STAFF REPORT: 10/09/2024 MEETING PREPARED BY: J. ROSS

ADDRESS: 1760 VAN DYKE

APPLICATION NO: HDC2024-00517 **HISTORIC DISTRICT**: WEST VILLAGE

SCOPE: REPLACE SEVEN (7) WOOD WINDOWS

Deterioration at corner of WINDOW A-01. 10/30/2024 HDC staff

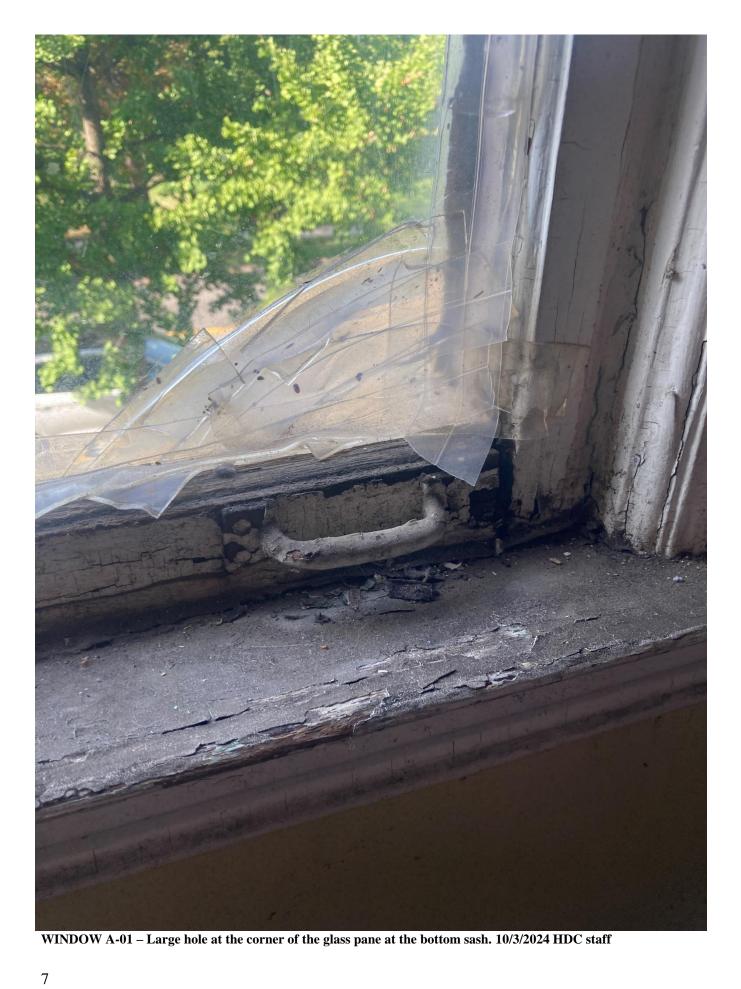
WINDOW A-01 —Gaps at top and sides glass pane in both bottom and top sash; large hole at the corner of the glass pane at the bottom sash. Wood components appear to be in repairable condition 10/3/2024 HDC staff

WINDOW A-02 – Gaps at sides of glass pane in both bottom and top sash; large hole at the corner of the glass pane at the bottom sash. Wood components appear to be in repairable condition. 10/3/2024 HDC staff

WINDOW A-01 – Showing extant sash cords. 10/3/2024 HDC staff

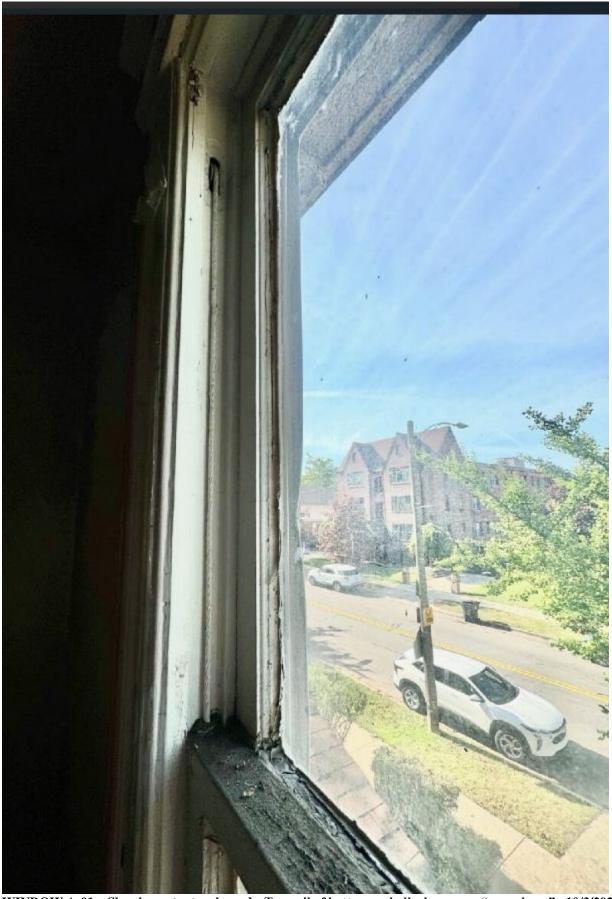
WINDOW A-01 – Showing extant sash cords. Top rail of bottom sash displays some "sponginess". 10/3/2024 HDC staff

WINDOW D – Covered with plastic due to extreme air infiltration/gaps in glass panes at top and bottom sash; bottom rail at top sash is failing/about to fall off. Other wood components appear in fair/repairable condition. Photo by applicant

WINDOW D – Covered with plastic Photo by applicant

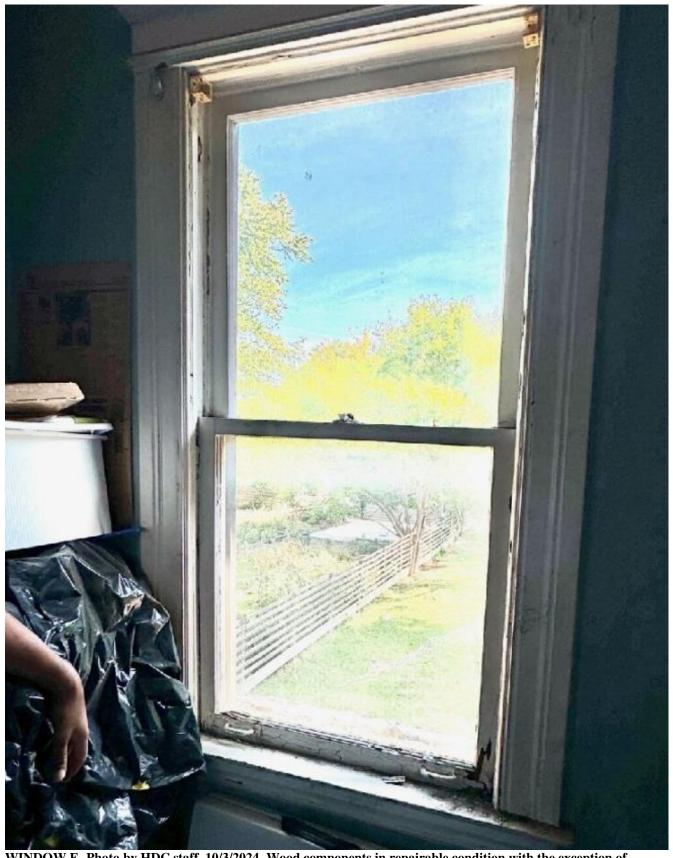
WINDOW D — Note poor/deteriorated condition of the bottom rail of the upper sash. 10/3/2024 photo by HDC staff

WINDOW E- Photo by HDC staff, 10/3/2024. Wood components in repairable condition with the exception of some rot at bottom rail

WINDOW E- Photo by HDC staff, 10/3/2024. Area of rot at bottom rail, showing previous repair
